Office Action Summary

10/588,167

WIRTH ET AL.

DETAILED ACTION

Fig. 3

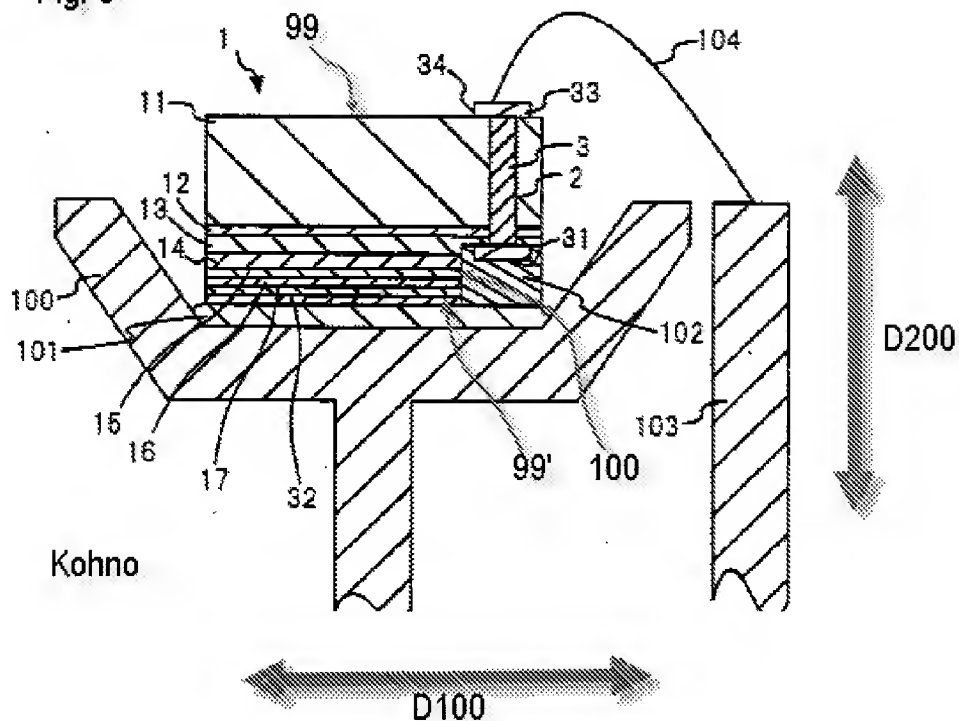
In regards to claim 1, Kohno discloses (Fig. 3, See annotated and attached Fig. 3 below) an optoelectronic component comprising a semiconductor function region **(4)** with an active zone **(15)** and a lateral main direction of extension **(D100)**, wherein said semiconductor function region **(4)** is provided with at least one opening **(10)** through said active zone **(15)**, and disposed in the region of said opening **(10)** is a connecting conductor material **(31)** that is electrically isolated from said active zone **(15)** at least in a subregion of said opening.

In regards to claim 2, Kohno discloses (Fig. 3, See annotated and attached Fig. 3 below) an optoelectronic component comprising a semiconductor function region **(4)** with an active zone **(15)** and a lateral main direction of extension **(D100)**, wherein said semiconductor function region **(4)** is provided with a lateral side face **(100)** bounding said active zone **(15)**, and disposed

In regards to claim 3, Kohno discloses (Fig. 3, See annotated and attached Fig. 3 below) said connecting conductor material (31) is at least partially electrically isolated from said active zone (15) by an isolation material (102).

In regards to claim 4, Kohno discloses (Fig. 3, See annotated and attached Fig. 3 below) said opening (10) is configured as a depression in the lateral direction (D100) or said side face (100) is provided with a depression in the lateral direction (D100).

In regards to claim 5, Kohno discloses (Fig. 3, See annotated and attached Fig. 3 below) said isolation material (102) at least partially lines said opening (10+2).

In regards to claim 6, Kohno discloses (Fig. 3, See annotated and attached Fig. 3 below) said opening (10) extends in the vertical direction (D200) all the way through said semiconductor function region (4).

In regards to claim 7, Kohno discloses (Fig. 3, See annotated and attached Fig. 3 below) said semiconductor function region (4) comprises a first main face (99) and a second main face (99') located oppositely from said first main face (99) relative to said active zone (15), and said

In regards to claim 8, Kohno discloses (Fig. 3, See annotated and attached Fig. 3 below) said connecting conductor material (31) is electrically isolated from said second main face (99') of said semiconductor function region (4).

In regards to claim 13, Kohno discloses (Fig. 3, See annotated and attached Fig. 3 below) said semiconductor function region (4) is disposed on a carrier (11).

In regards to claim 14, Kohno discloses (Fig. 3, See annotated and attached Fig. 3 below) said connecting conductor material (31) extends to a side of said carrier (11) that is opposite said semiconductor function region (4).

In regards to claim 9, Kohno discloses (Fig. 3, See annotated and attached Fig. 3 below) said opening (**10**) but fails to explicitly teach that the lateral dimension of said opening is equal to 100 μm , or less.
